CHANGE/ERRATA INFORMATION

Title: 8000A
Print Date: March 1976
Rev.- Date: 1-5/79

Rev.-AH A1 Main PCB Assembly (8000A-4011)

Figure 1.

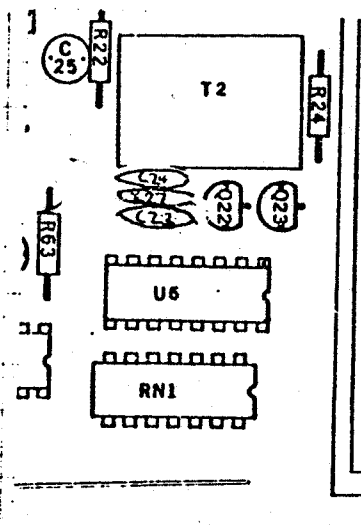
CHANGE: C27| CAP, TA, 10 UF $\pm 20\%$, 20V | 330662| 56289
 | 196D106X0020JA1 | REF
 TO: C27| CAP, CER, 0.22 UF $\pm 20\%$, 50V, Z5U| 519157| 51406
 | RPE111Z5U224M50V| 1
 ADD: C24| CAP, CER, 0.22 UF $\pm 20\%$, 50V, Z5U| 519157| 51406|
 | RPE111Z5U224M50V| 1

On pages 5-13 and 8-5, Figures 5-4 and 8-2, make the following changes as shown in Figures 1 and 2 of this change/errata.

CHANGE: CR26| DIODE, SI, (8000-01,-015,-016)| 07910| 1N4448| REF
 TO: W2| JUMPER, WIRE, TEFLON INSUL, 0.500CTR| 484311| 89536| 484311| 1

On pages 5-13 and 8-5, Figures 5-4 and 8-2, make the following changes as shown in Figures 1 and 2.
